**Re: Environmental Impact of the Rosemont Mine on Davidson Canyon and Cienega Creek**

**RESPONSE TO POWELL ET AL. (2015), "NEW ANALYSIS OF  
STORMFLOW AND GROUNDWATER DATA FROM DAVIDSON  
CANYON: EVIDENCE FOR INFLUENCE OF STORMWATER  
RECHARGE OF GROUNDWATER"**

**Seeing the Water for the Models: Pima County's Modeling of Rosemont Mine Impacts on Water Resources in Davidson Canyon Remains Robust Despite Comments by Westland Resources et al. (2016)**

**Figure 1. Stage and Discharge Data for ALERT Gauge 4310, 7/15 – 11/25/2015**

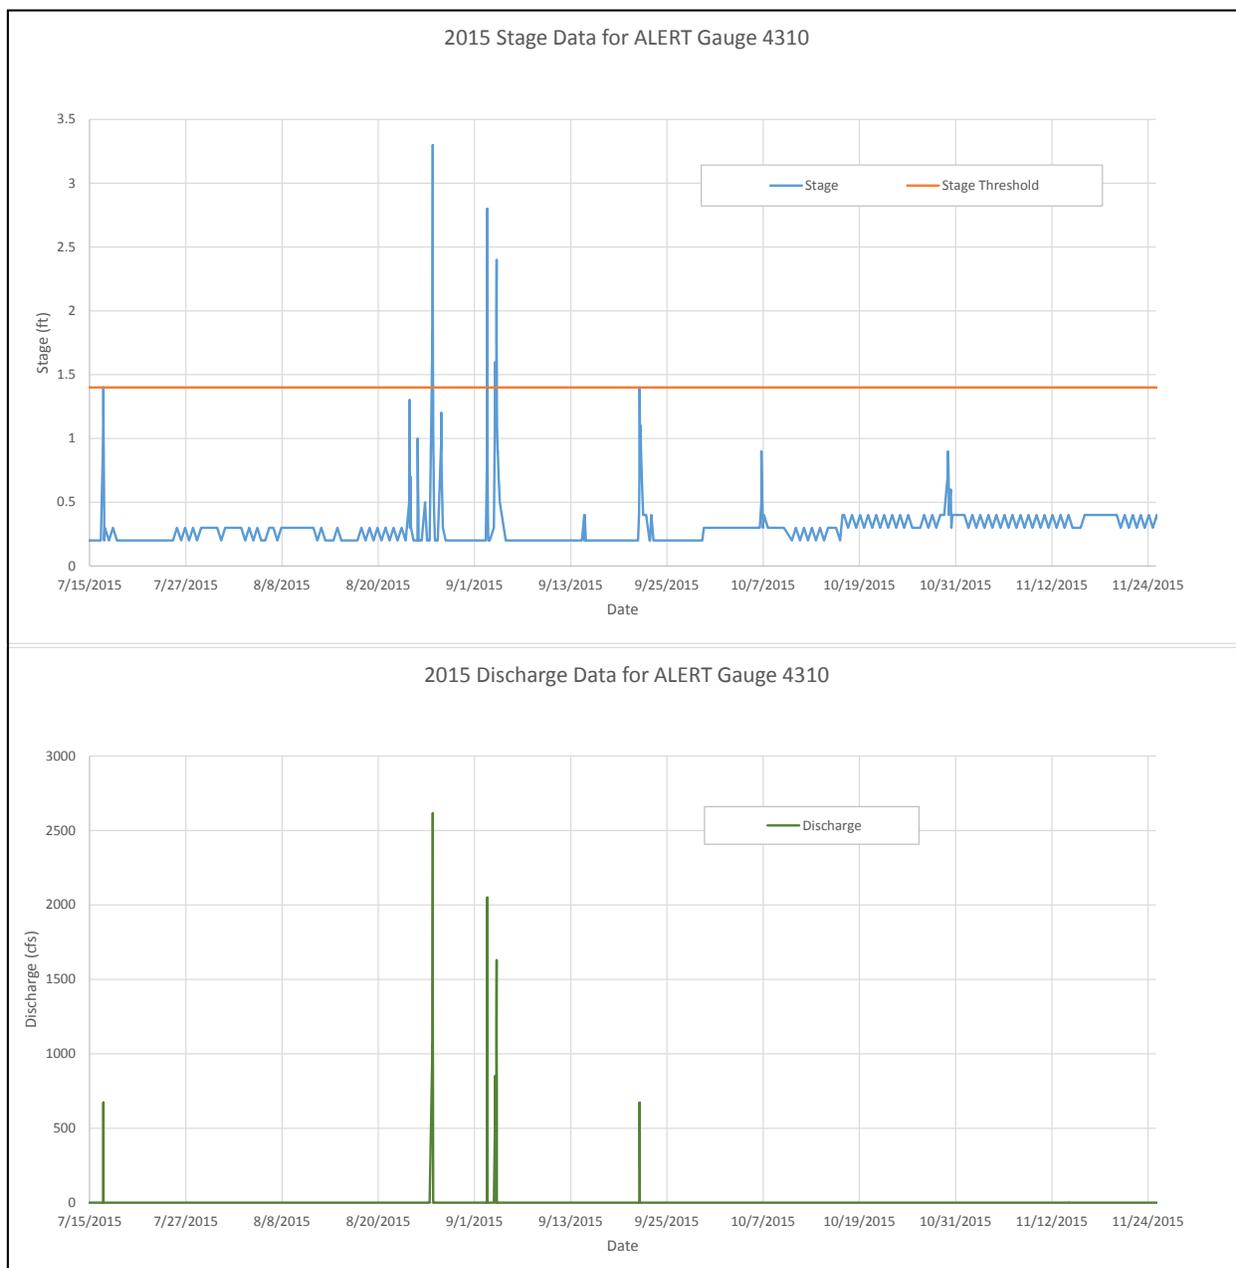
Based on the review of the ALERT stage and discharge data, the minimum stage where discharge is estimated is 1.4 feet, with a corresponding discharge of 674 cfs. As an ALERT gauge installed to provide flood early warning as its primary intent, Davidson Canyon ALERT gauge *only defines flow when the stage exceeds 1.4 feet above the channel.*

All measured stage values below 1.4 feet correspond to a reported flow of 0 cfs. The ALERT gauge data indicate that runoff conditions measured at this gauge with flows between 0 and 674 cfs are not being reported. The stage and discharge data for 7/15 - 11/25/2015 are presented in **Figure 1**. The stage at 1.4 feet where non-zero discharge is reported (stage threshold) is also shown. Small stage values (e.g., < 0.5 feet) and variations (e.g., +/- 0.1 foot) shown in the stage data presented in **Figure 1** likely represent common sensor measurement errors that can be caused by extreme heat or long periods of dry conditions.

Investigation into the measured stages during 7/15 – 11/25/2015 show that non-zero estimates of discharge were reported for only five (5) runoff hydrographs (shown in green in **Figure 1**) in that period. There were an additional six (6) events with measured stages greater than or equal to 0.5 feet but less than 1.4 feet during 2015 (shown in blue in **Figure 1**). For these six events, discharges of zero (0) cfs were provided in the ALERT data record.

All flows from 7/15 – 11/25/2015 with measured stages less than 1.4 feet were unaccounted. This includes three (3) events between 1.0 foot and 1.3 feet. Discharge during these smaller events is

significant, considering that the rated discharge for a stage of 1.4 feet is 674 cfs. The cumulative volume of runoff from hydrographs with stage magnitudes less than 1.4 feet were not included in the runoff volume computations presented in Powell et al. (2015). The total volume calculated does not account for all runoff at the gauge, and underestimates the actual runoff volumes during the 2015 analysis period. Therefore, Powell et al. (2015) is overestimating the flow contribution from Barrel Canyon. The true runoff contribution of Barrel Canyon as a fraction of Davidson Canyon runoff for these specific flow events cannot be determined with the data available.

**Figure 3. Precipitation measured by several Pima County ALERT rainfall gauges in and near Davidson Canyon. Total measured rainfall during 7/15-11/25/2015**

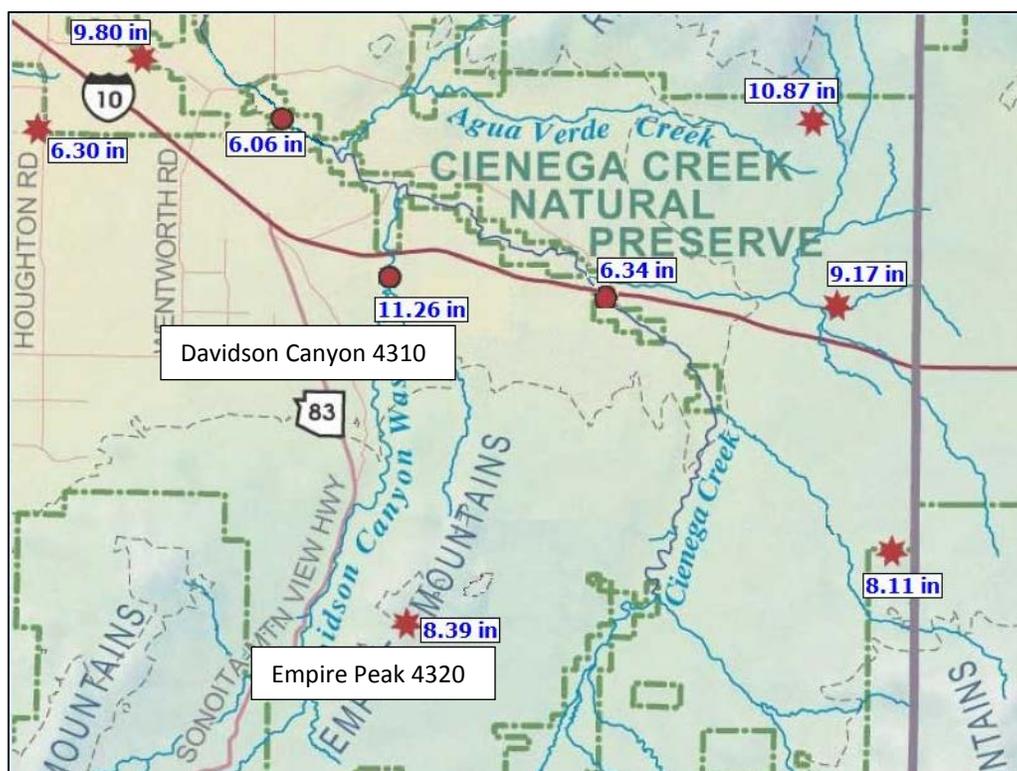
In addition, the higher elevation gauge (Empire Peak) measured less precipitation during this time in 2015 (Table 3 and Figure 3). The two ALERT gauges lie within the Davidson Canyon watershed at elevation differences greater than 2,000 feet (Table 2). Rainfall totals during July 15 through November 25, 2015 indicate that the lower elevation Davidson Canyon ALERT Gauge 4310 measured almost 3 inches more rainfall (35 percent greater) than the higher elevation Empire Peak gauge 4320 (Figure 3). Figure 3 also demonstrates variability in rainfall totals measured at other station locations near Davidson Canyon watershed. During this very narrow time period the seven (7) other nearby rain gauges also did not show the orographic precipitation effect stated by Powell et al. (2015).

**Figure 4. Daily Total Runoff**

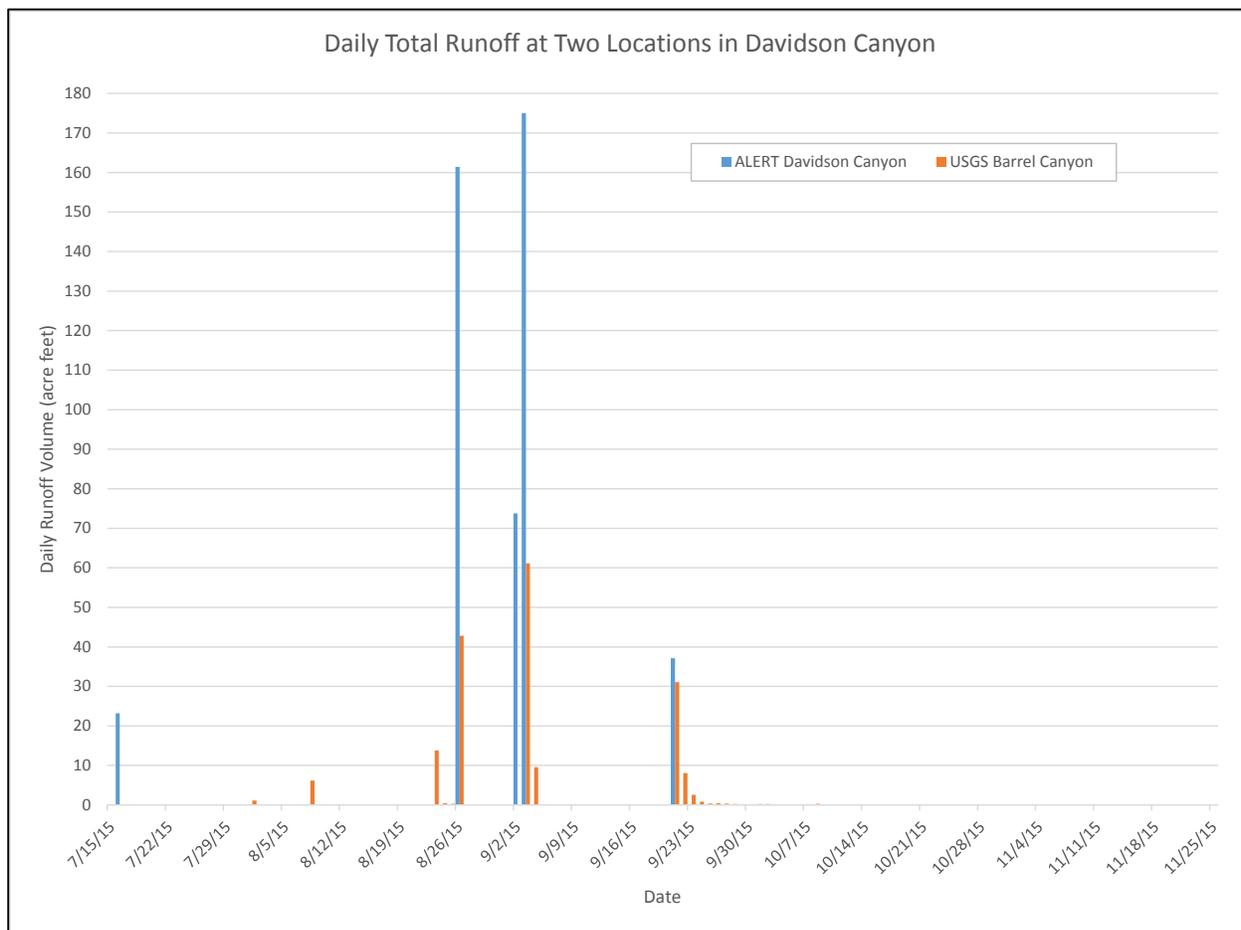
Total runoff volumes from July 15 through November 25, 2015 at the two gauges are shown graphically in **Figure 4**, which demonstrates the variability in timing of runoff between the two gauges. There were occurrences of runoff measured at the Barrel gauge on days when no runoff was measured at the Davidson gauge. Conversely, there were days when the Davidson gauge measured runoff when no runoff was measured at the Barrel gauge. There are only three (3) measured runoff events during this time period when runoff was measured at both gauges on the same day.

The number of days with measured runoff for the same time period are shown in **Table 4**. There were more days with measured runoff at the Barrel Canyon gauge as compared to the Davidson Canyon ALERT gauge. This may be due, in part, to runoff with stages less than 1.4 feet not being recorded at the Davidson Canyon ALERT gauge.

**Figure 7. Davidson Canyon flow length versus depth to water at well Davidson #2. Data from Figure 5 of Powell et al. (2014).**

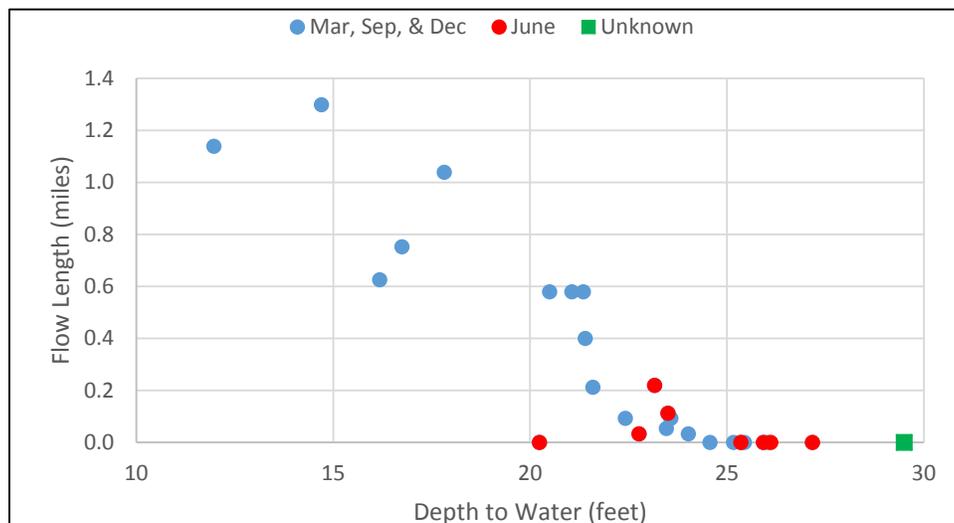
**Figure 7** shows the data from Figure 5 of Powell et al. (2014). There are twenty-six data points, with eight from June plotted in red, and one from an unknown date plotted as a green square. The *flow length* is zero for nine of the sample points. For the nine sample points with zero *flow length*, the Powell et al. (2014) *depth to water* ranges from 20.2 feet to 29.5 feet, with a range of 9.3 feet. The range of *depths to water* for all sample points is 17.5 feet (12.0 to 29.5 feet). The range of *depth to water* for sample points with zero *flow length* covers over half the total range for the sample.

The sample data were modeled using simple linear regression instead of a model that accounts for censored data. This means that any predictions, such as the 30 percent reduction in flow length due to a 0.98-foot increase in depth to water (Powell et al. 2014), are invalid.

**Figure 8. Davidson Canyon flow length versus depth to water at well Davidson #2. Data from Figure 5 of Powell et al. (2014).**

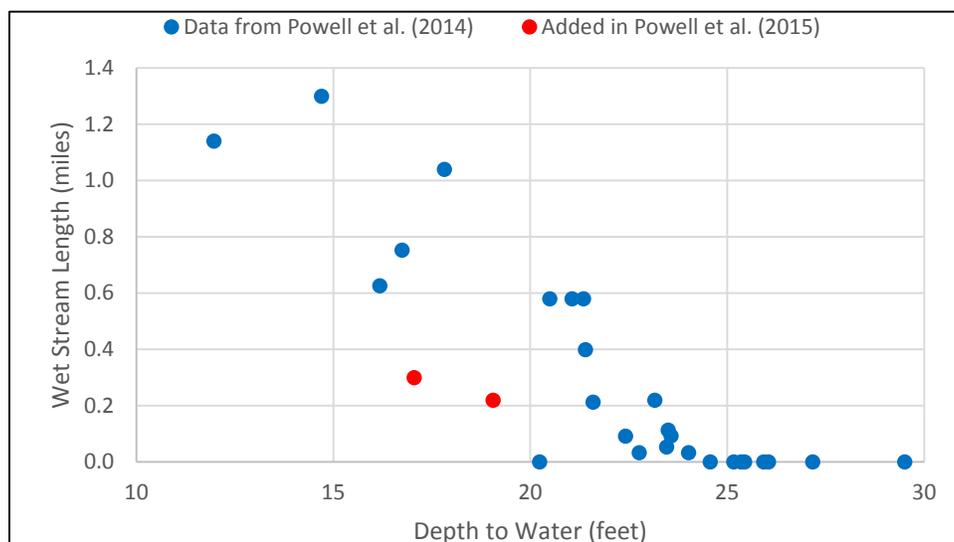
Figure 8 shows the data from Figure 6 of Powell et al. (2015). The points in Figure 8 are the same as Figure 7 except that two points (plotted in red) have been added<sup>1</sup>. The data in Figure 8 still include nine sample points with flow length equal to zero, and cannot be modeled using linear regression as was done in both Powell et al. (2014) and Powell et al. (2015).

**Figure 4. Non-truncated dataset of all storm water discharge, including flows of less than 1.4 feet, at ALERT site 4313 in Davidson Canyon for July 15 – November 25, 2015.**

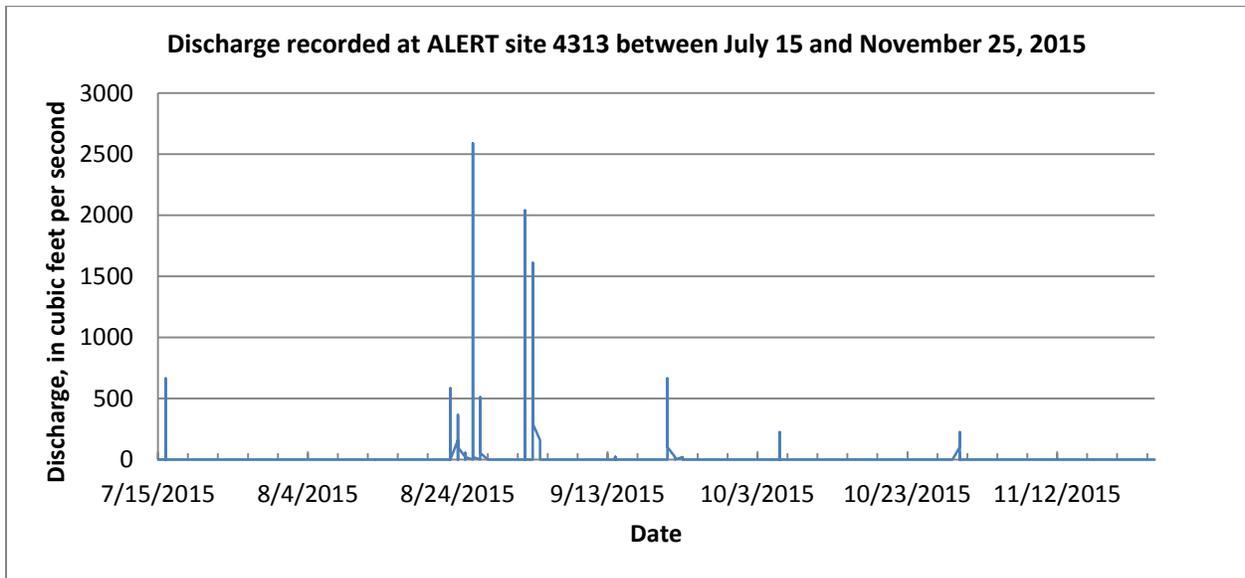
The ratings used to display data on the ALERT website <http://alert.rfcd.pima.gov/perl/pima.pl> are sometimes intentionally truncated for a variety of reasons, and the truncated data set was used in the Powell et. al (2015) report. The complete data set, with discharge estimates for all stage values (including those below 1.4 feet for the period of July 15 – November 25 2015), is included in Figure 4.

Assigning discharge values to low flows increases the total flow volume calculation for the period of July 15 – November 25 of 2015 from 470 acre-feet—as reported in Powell et al. (2015)—to approximately 1600 acre-feet. The 470 acre-feet figure suggested that a disproportionately large percentage of total Davidson Canyon watershed volume is produced by Barrel Canyon. While the higher estimates of surface flow seems to counter our original argument, it is, as pointed out by Westland et al. (2016) a very short data set and the distance between the USGS gage at Barrel Canyon makes quantifying the overall flow contribution from these watersheds a difficult exercise for both Pima County and Rosemont. Neither Pima County nor Westland's analyses can correct the fact that the FEIS has done an inadequate job at describing the proposed Rosemont mine's impact on stormwater and baseflows in Barrel and Davidson canyons.

**Figure 5. Runoff volume (acre feet) comparison between Davidson and Barrel canyon showing their close correlation.**

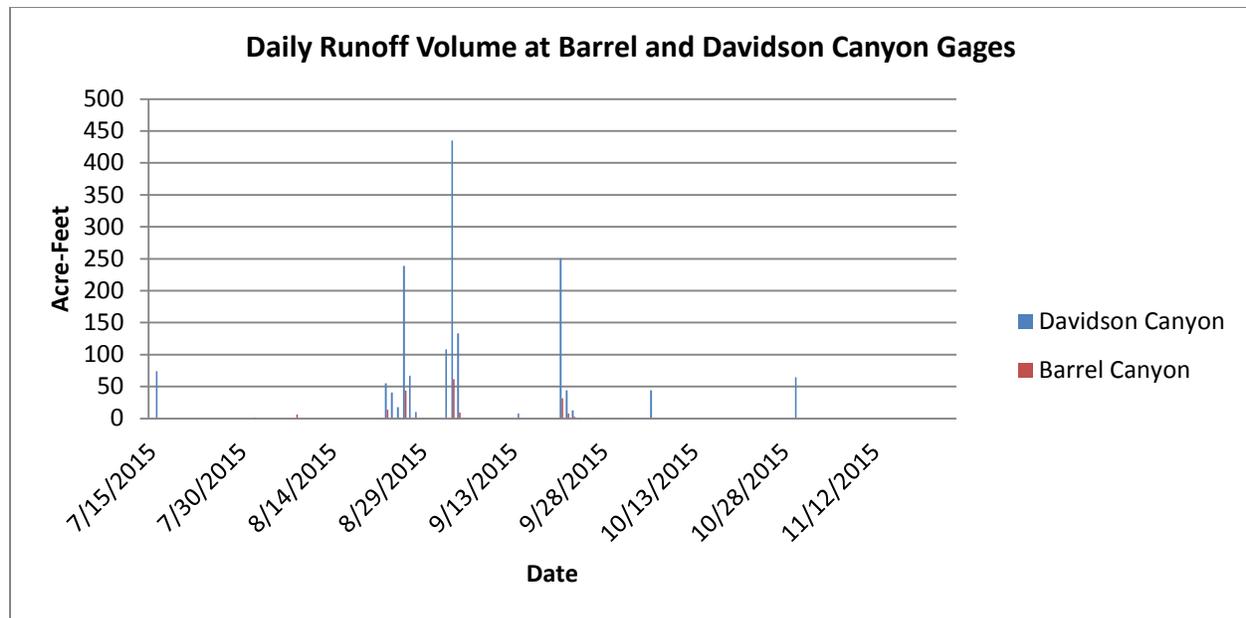
Westland et al. (2016) presents a discussion of runoff variability between the USGS gauge 09484580 located at Barrel Canyon and the ALERT site 4313 streamflow gauge. It is unclear what exactly they are trying to establish but they show that runoff occurred at both locations on the same day on only three occasions during the July 15 – November 25, 2015 sampling period. As noted above, Westland et al. (2016) used an incomplete record of discharge for their analysis. In actuality, when using the complete dataset (Figure 5), it is clear that 70-percent of runoff events measured at the Davidson Canyon ALERT gage occurred on days where discharge was also recorded at Barrel Canyon. Barrel Canyon recorded more days of runoff than Davidson Canyon, but 50-percent of the runoff events recorded at Barrel Canyon also corresponded with days where runoff was measured at Davidson Canyon. As we have already acknowledged and pointed out, this temporally narrow data set is not sufficient to fully describe long-term watershed characteristics, but it does suggest that runoff events in the upper and lower watershed are not as temporally isolated as Westland et al. (2016) claim.
